# **Townhomes at Gattis** CONCEPT PLAN CP1812-002

**CASE PLANNER: JUAN ENRIQUEZ REQUEST:** Approval of a Concept Plan

**DATE OF REVIEW:** January 9, 2019

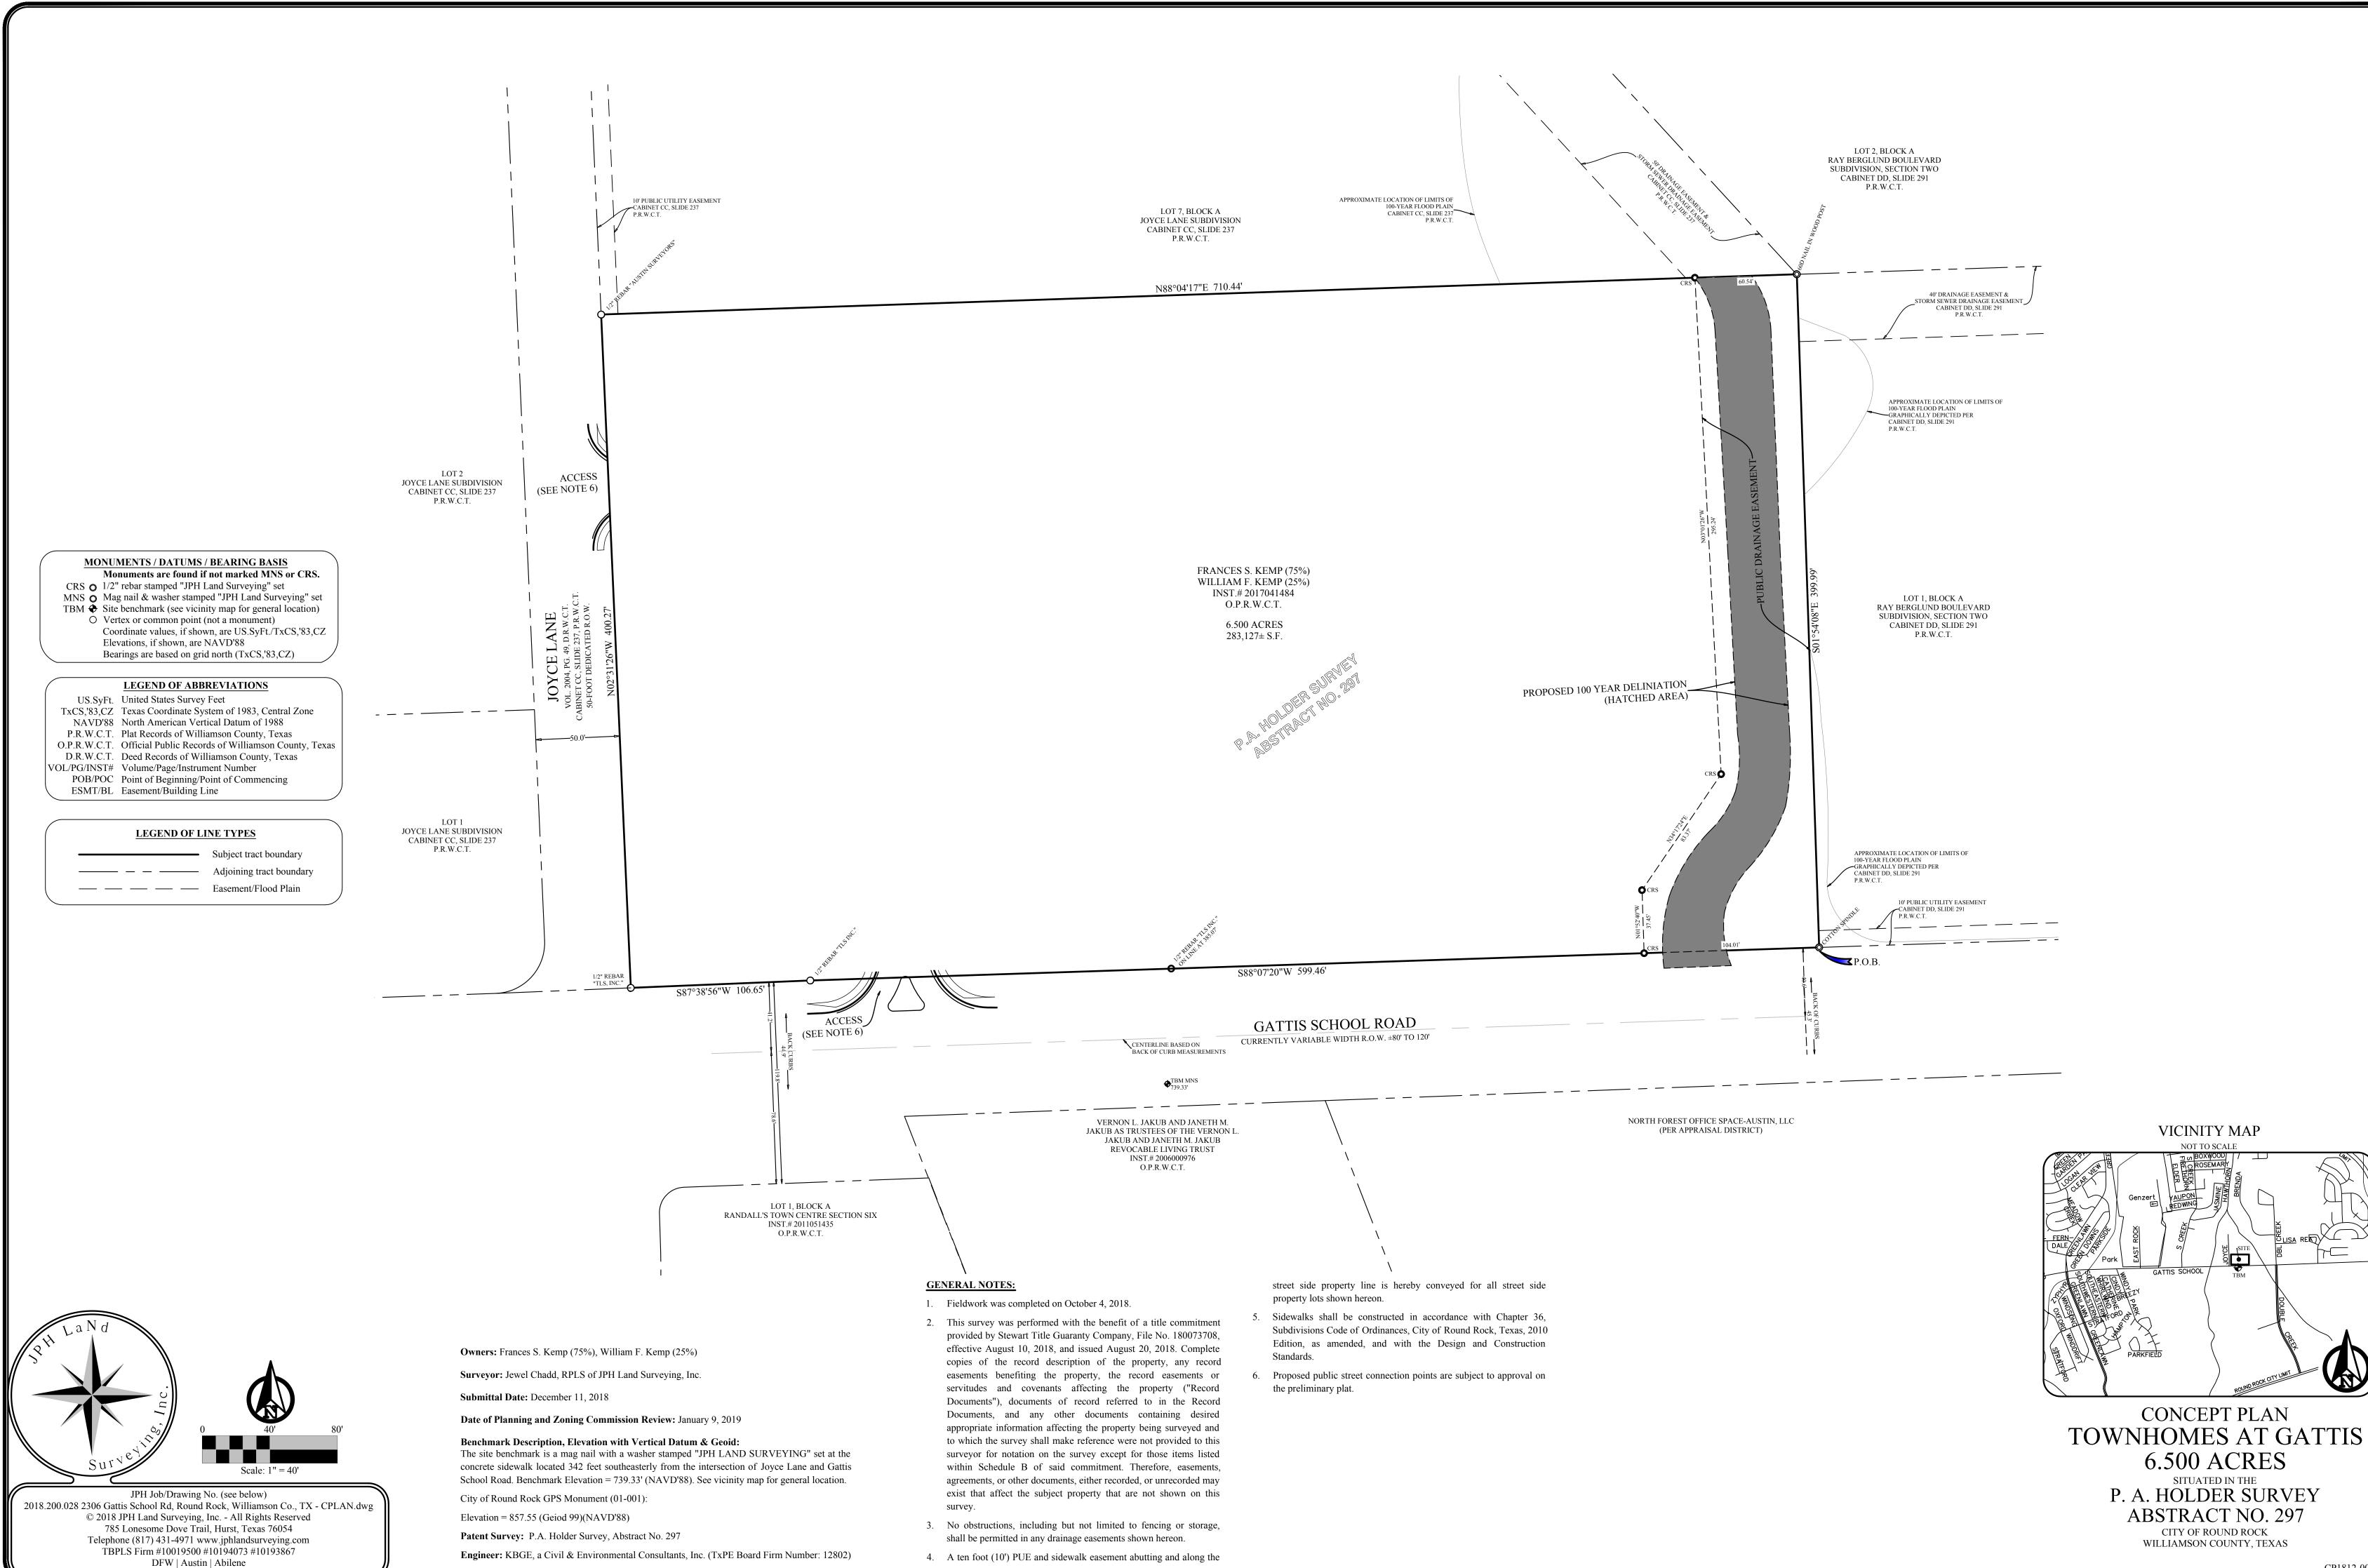
- Include the following plat note "A second point of access, meeting all criteria of the most recently adopted Fire Code, as amended, shall be required on all plats of residential subdivisions containing greater than 29 dwelling units."
- 2. Remove plat notes numbers 4 and 5.
- 3. Provide a survey tie across rights-of-way with bearings and distance calls.
- 4. Remove curb linework from schematic.
- 5. Remove general notes 1 and 2 regarding field work completion and survey work in absence of title work, respectively.
- 6. Provide only known floodplain limits. Remove depiction of proposed 100-yr limits if not based on an approved flood study.
- 7. Provide easement depiction for 15" wastewater line adjacent to the northeast property corner. If an easement is also proposed to tie in to a main on private property to the southwest, provide a depiction of that easement as well.
